HCOM-SB-72A

Subject: Model "E" Compressor Terminal-Plate Retaining Ring and Cap Screw Changes

Figure 1
Junction Box Assembly
(Model "E" Semihermetic
Compressors)

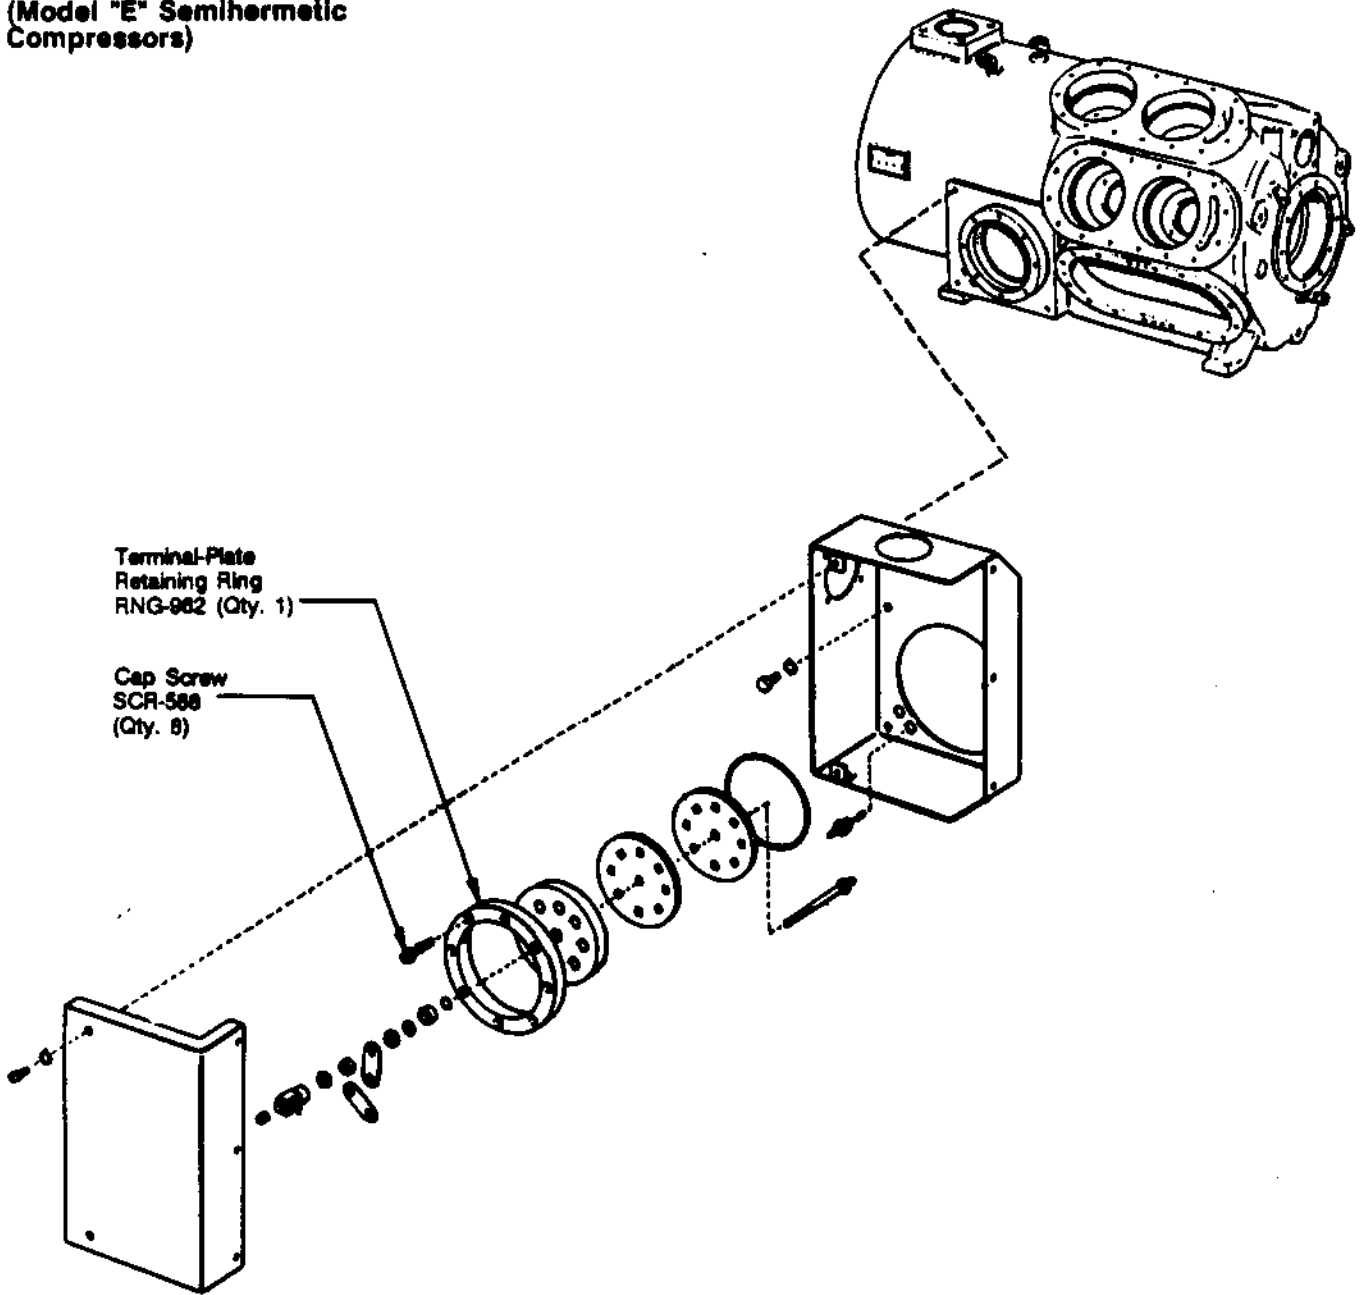
A design change was made to the terminal-plate retaining ring and cap screws used in the junction box assembly on all Model "E" semihermetic compressors. Original parts affected by this change are SCR-53 and RNG-132.

Whenever changeout of an original terminal-plate retaining ring (RNG-132) or cap screw (SCR-53) is necessary, be sure to replace both the ring and all 8 cap screws (Figure 1) with the redesigned components. The new part numbers for these items are RNG-962 and SCR-588.

Order new terminal-plate retaining rings and cap screws from La Crosse, "Ship from 31": specify these part numbers:
SCR-588 = New Cap Screw (8 required)
RNG-962 = New Terminal-Plate Retaining Ring

Terminal-Plate
 Retaining Ring
 RNG-982 (Qty. 1)

Cap Screw
 SCR-588
 (Qty. 8)
